# Mounting kit upgrade for the BQ series tanks (625x680)

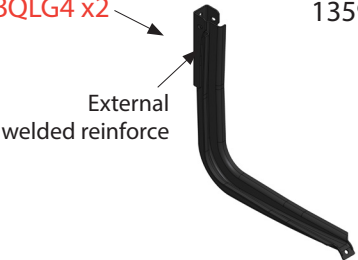
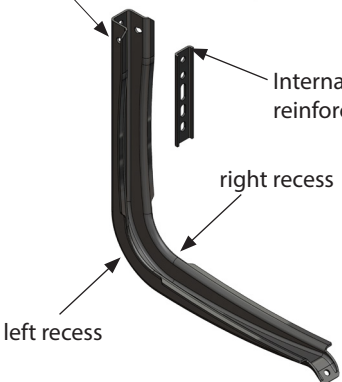
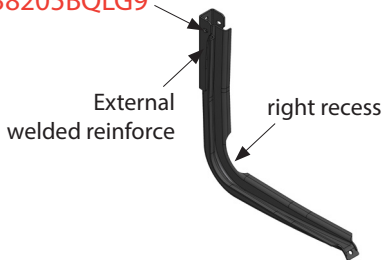
WAS	BECOMES
<p><b>538205BQLG4 x2</b></p>  <p>External welded reinforce</p> <p>135903BQLX0</p>	<p><b>538205BQLGD x2</b></p>  <p>left recess</p> <p>right recess</p> <p>135903BQLX0</p>
<p><b>538205BQLG8</b></p>  <p>left recess</p> <p>External welded reinforce</p> <p><b>538205BQLG9</b></p>  <p>External welded reinforce</p> <p>right recess</p> <p>135903BQLX2 (135 lt)</p>	<p><b>53800404397 x2</b></p>  <p>Internal reinforce</p> <p>135903BQLX0</p>

The standard mounting kit code remains unchanged as shown in the catalogue, the 135l tank kit code 135903BQLX2 is merged with the standard version 135903BQLX0. After these changes we managed to create the new spare parts numbers as shown in the table below:

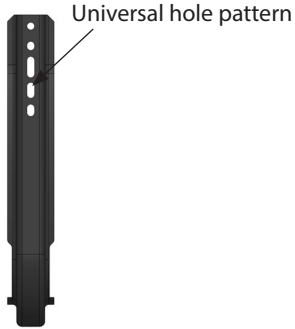
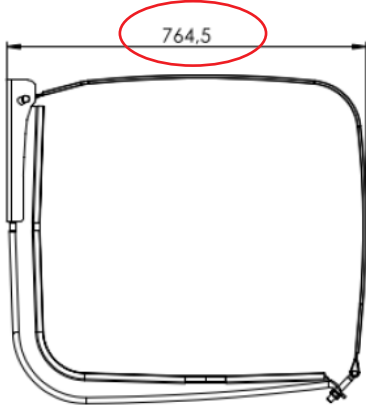
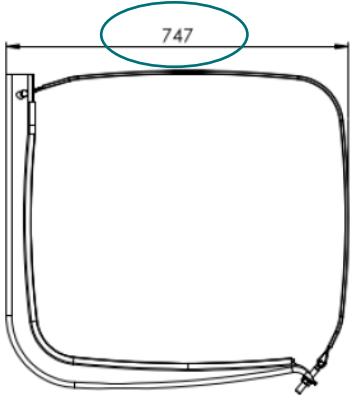
<b>WAS</b>	<b>BECOMES</b>
	<p>The new universal hole pattern allowed us to integrate the holes pattern of the new frames recently introduced on the market into a single solution, without handling specific supports or drill new holes on the chassis frame.</p> 
	<p>The new support shape can save 17,5mm of depth for the bracket + tank assembly, making it an extremely flexible solution, which can be installed quickly and easily even on vehicles with side fairings.</p>
